Title: SUPERCONDUCTING QUANTUM
INTERFERENCE APPARATUS AND
METHOD FOR HIGH RESOLUTION
IMAGING OF SAMPLES

Appl. No.: 10/650,263

PETITION TO CORRECT FILING DATE OF REPLY AND AMENDMENT
UNDER 37 CFR § 1.8 TRANSMITTAL

REPLY AND AMENDMENT

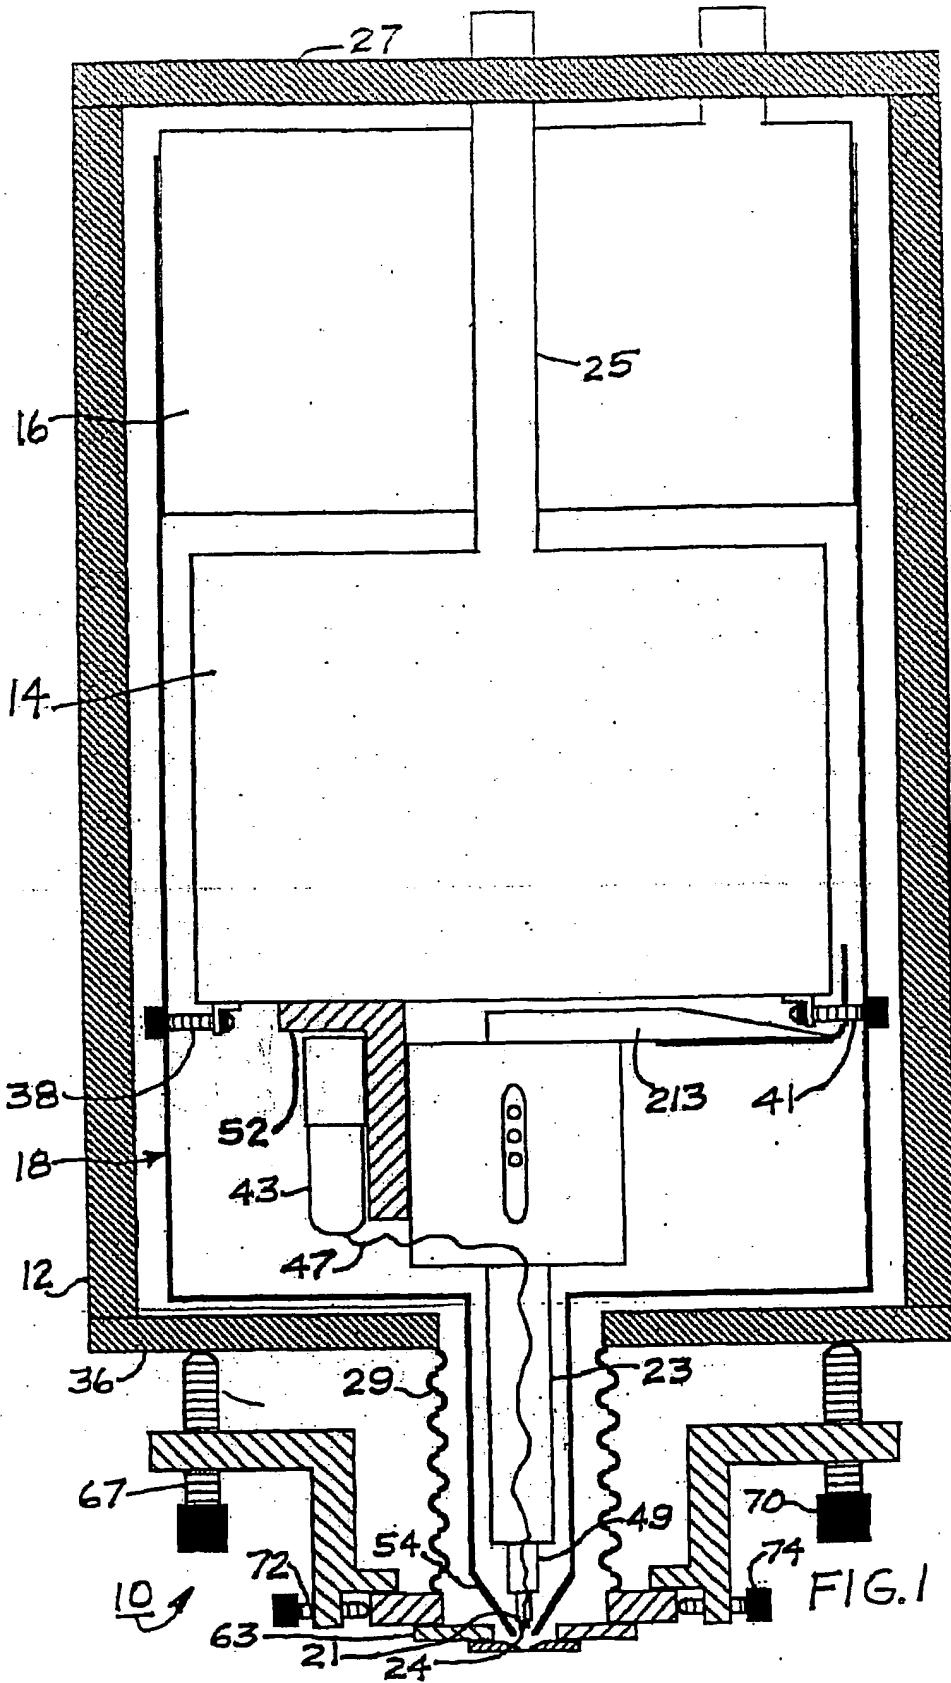
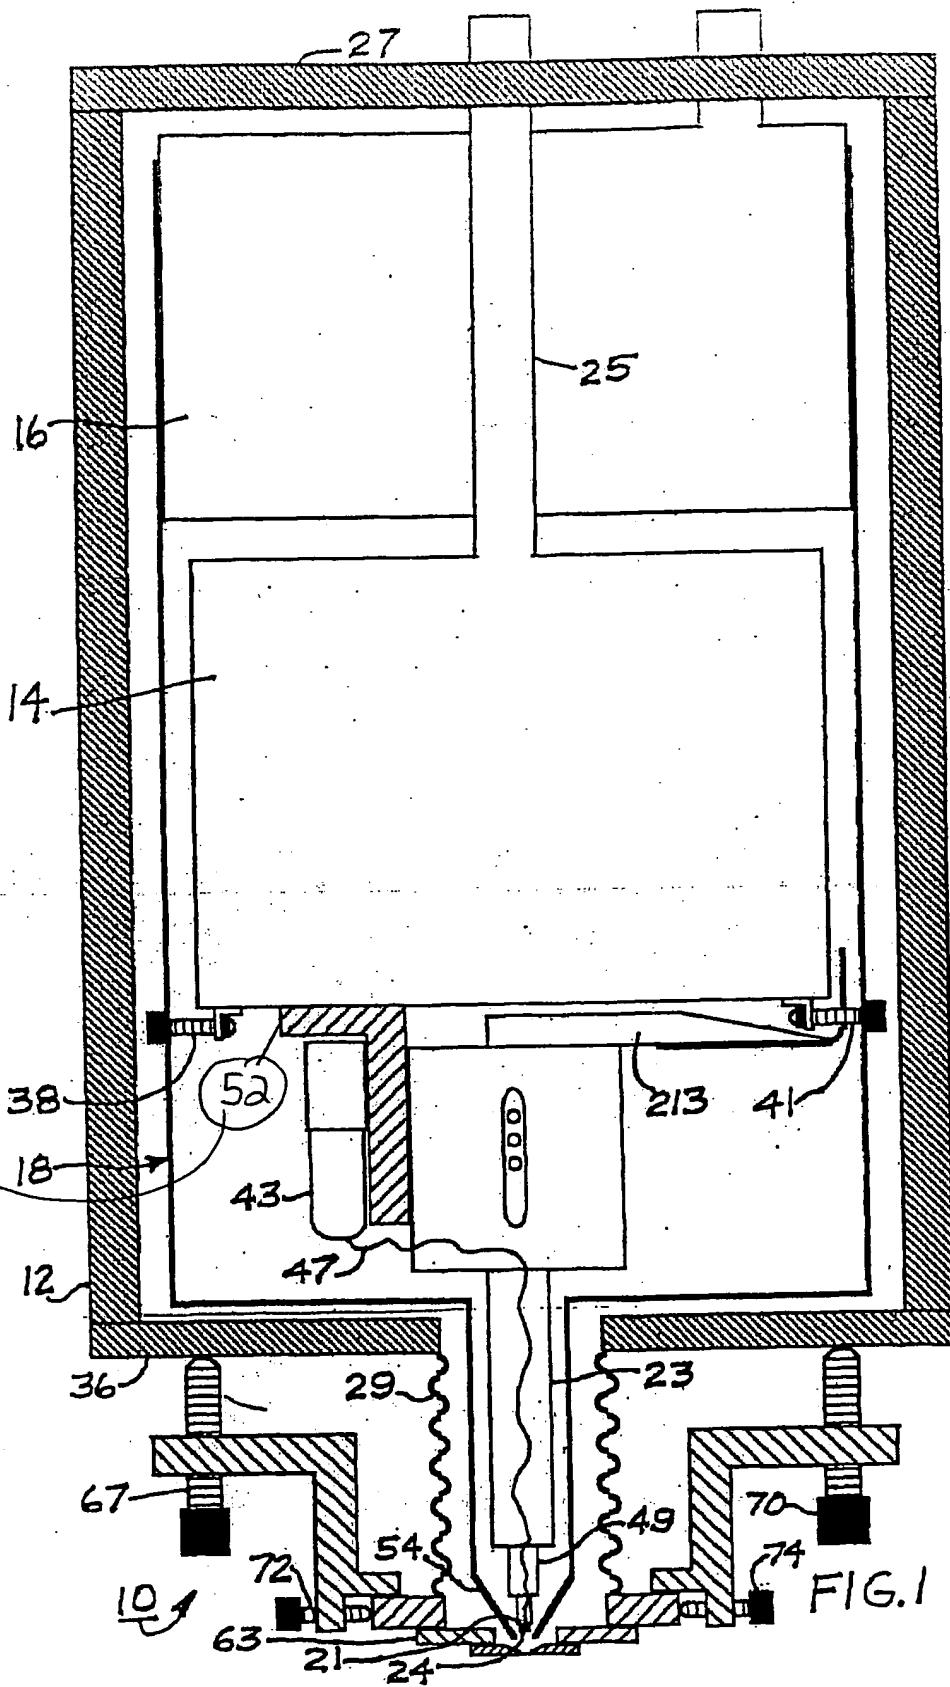
The attached drawing sheets include changes to Figure 1 and Figure 5. These sheets replace their respective original sheets. In Figure 1, previously omitted reference character 52 has been added, and in Figure 2, previously omitted reference character 87 has been added.

The drawings have been objected to as failing to comply with 37 CFR 1.84(p)(5) because they do not include reference signs mentioned in the description, namely the cold plate 52 and the motor 87.

Replacement sheets for Figure 1 and Figure 5 with an annotated sheet showing changes for these two figures have been provided. Figure 1 now shows the reference sign for the cold plate 52 and Figure 5 now shows the reference sign for the motor 87.

Application Number 10/650,266
Amendment Dated March 8, 2004
Reply to Office action of December 8, 2004
Annotated Sheet Showing Changes

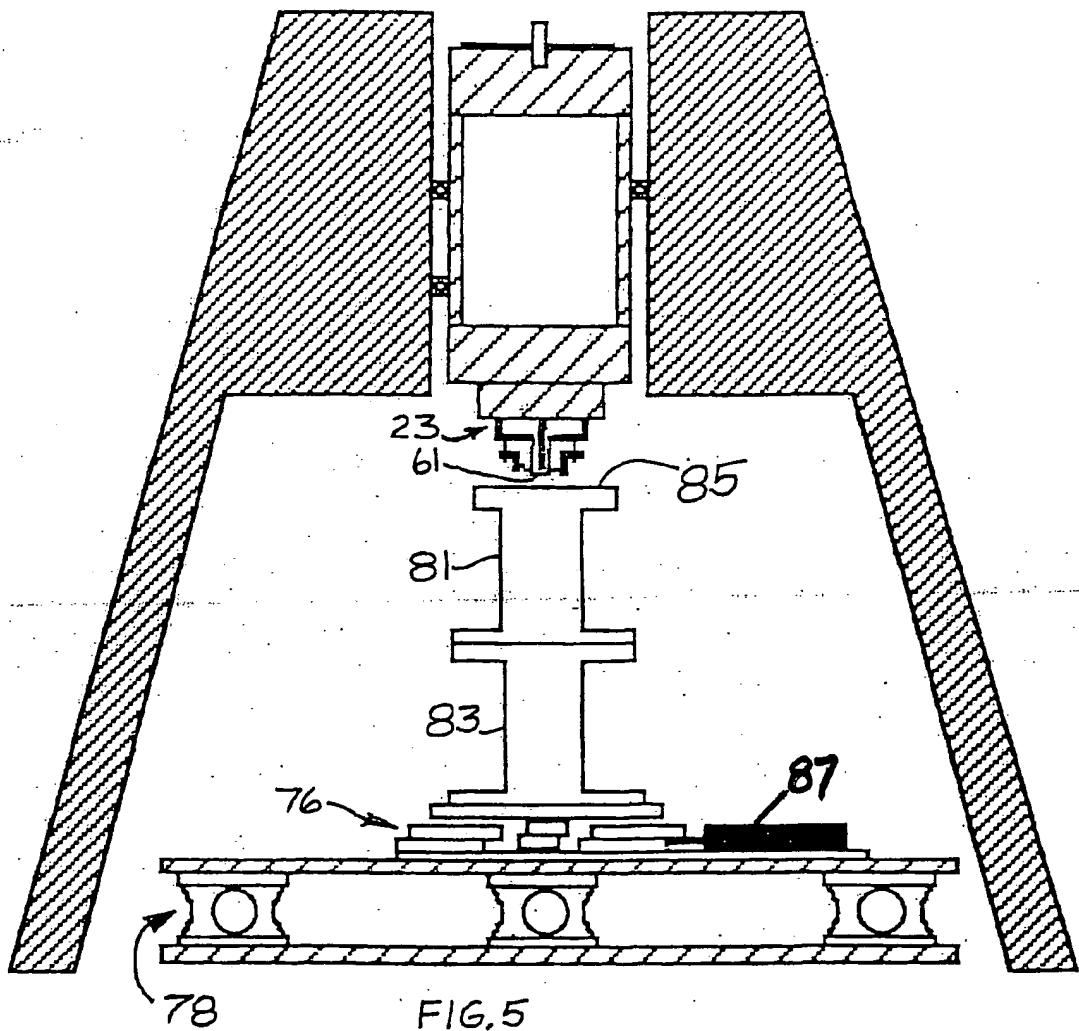
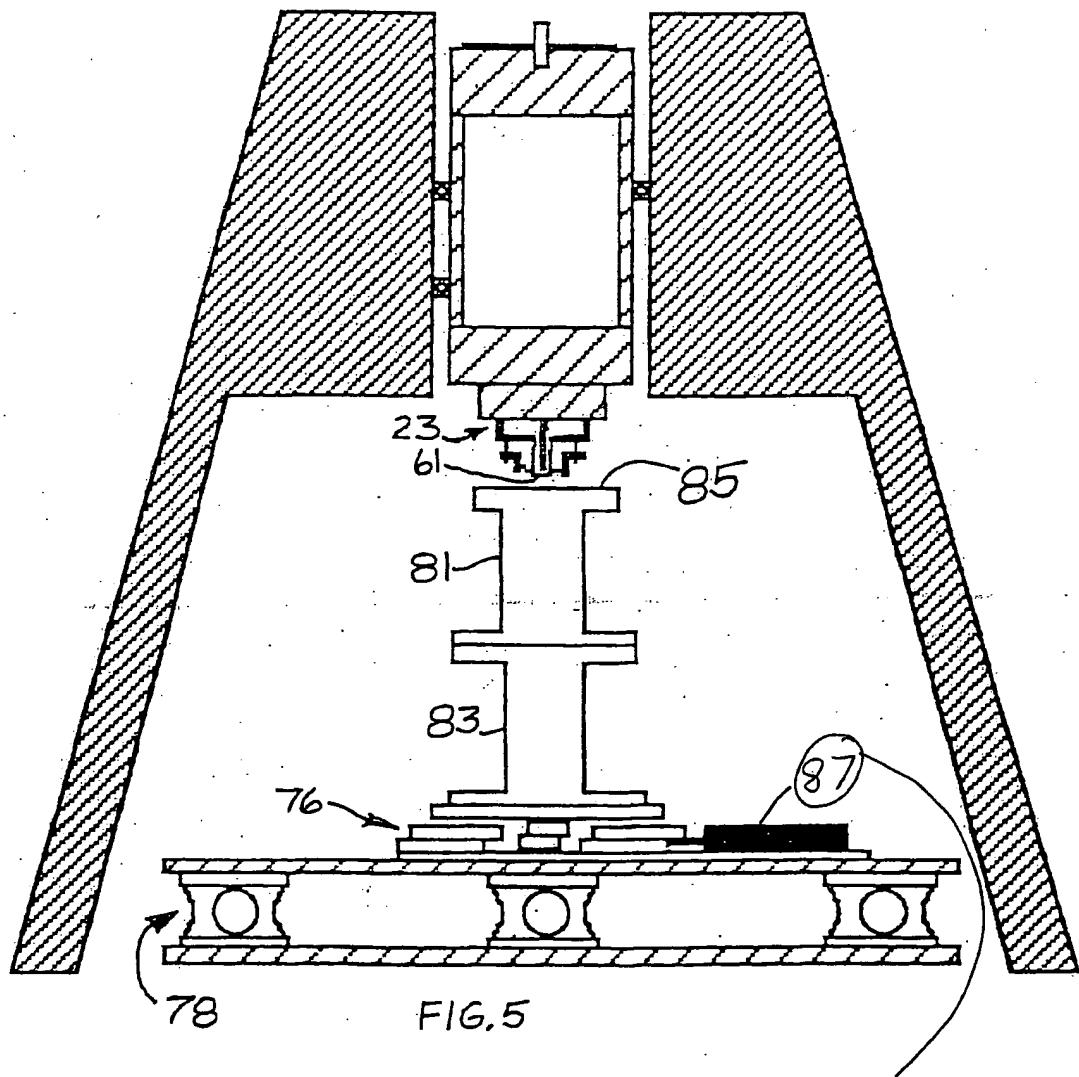
Element 87
added to the
drawings.
